BCA ASSESSMENT REPORT

**Lot 201, ESR Horsley Logistics Park
Horsley Park**

**Prepared For:
ESR Australia**

Revision 2

Figure 1 –Perimeter Vehicular Access per BCA C2.4.

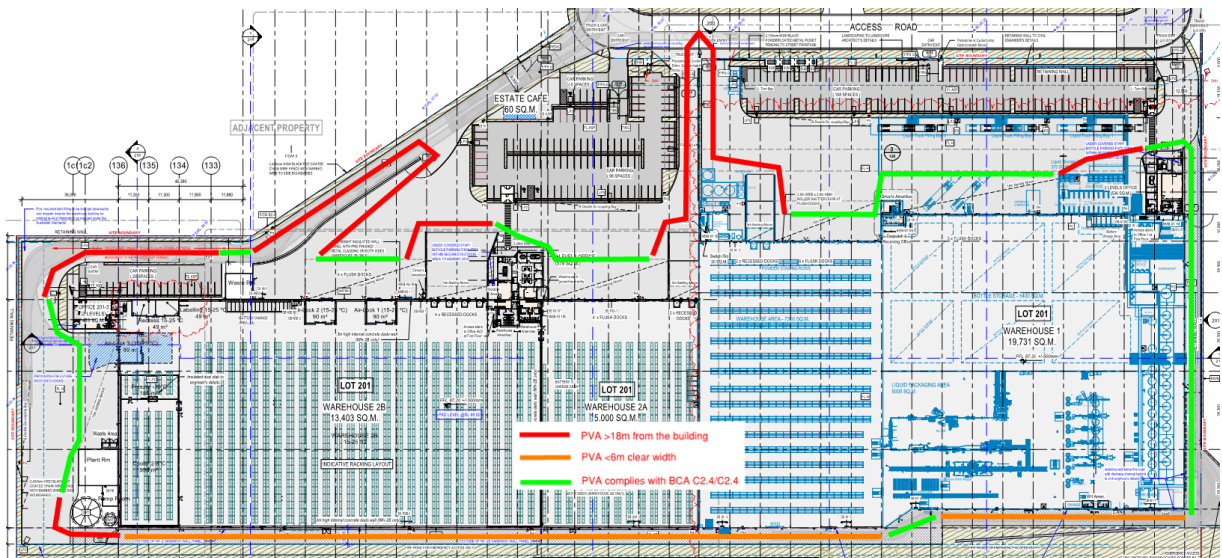
Comments: The proposed building does not comply with the provisions of C2.4 and thus the following non-compliance areas identified on the site plan are required to be addressed as a Performance Solution by the Fire Safety Engineer:

- *The furthest part of the vehicular access path is greater than 18m from the external wall along in the locations shown in red below.*
- *The perimeter vehicular access on the southern side of the building is less than 6m wide.*

Note 1: The driveways providing vehicular perimeter access must be designed with adequate loading capacities to withstand a fire truck and the gradients of the ramps should take into consideration to the FRNSW Policy 4 Vehicular Access Guideline.
